**Amendment-LII dated 11.10.2024 on the Request for Proposal Document and Transmission Service Agreement issued for selection of bidder as Transmission Service Provider to establish “Transmission system for evacuation of power from Luhri Stage-I HEP” through tariff based competitive bidding process.**

**Annexure-A**

Proposed Communication for **“Transmission system for evacuation of power from Luhri Stage-I HEP”**

Figure F.1 (Revised)

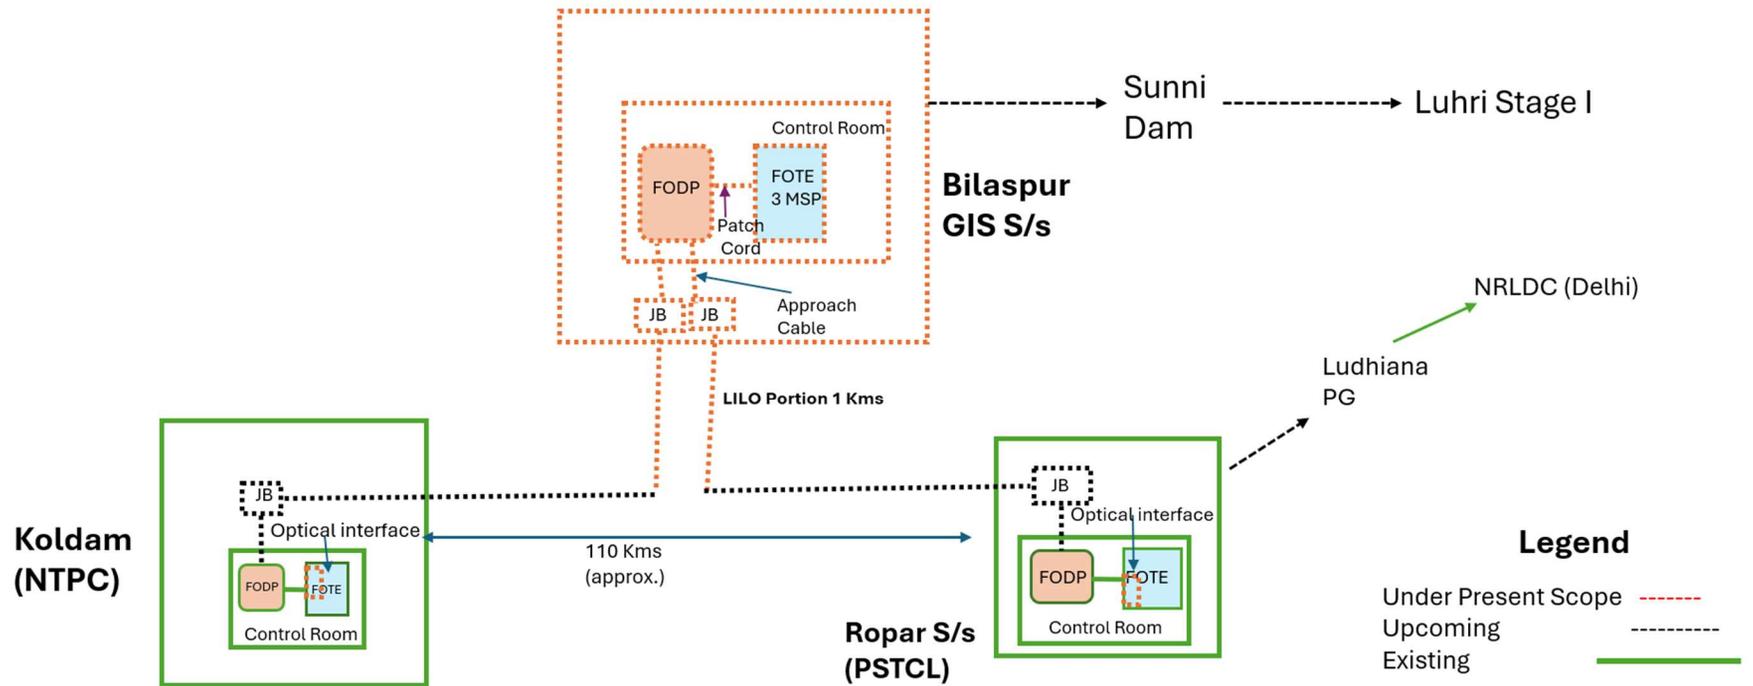
7.	<p><b>SPECIFIC TECHNICAL REQUIREMENTS FOR COMMUNICATION RFP &amp; TSA</b></p>	Figure F.1	<p><u>Revised figure F.1 is attached at Annexure A.</u></p>
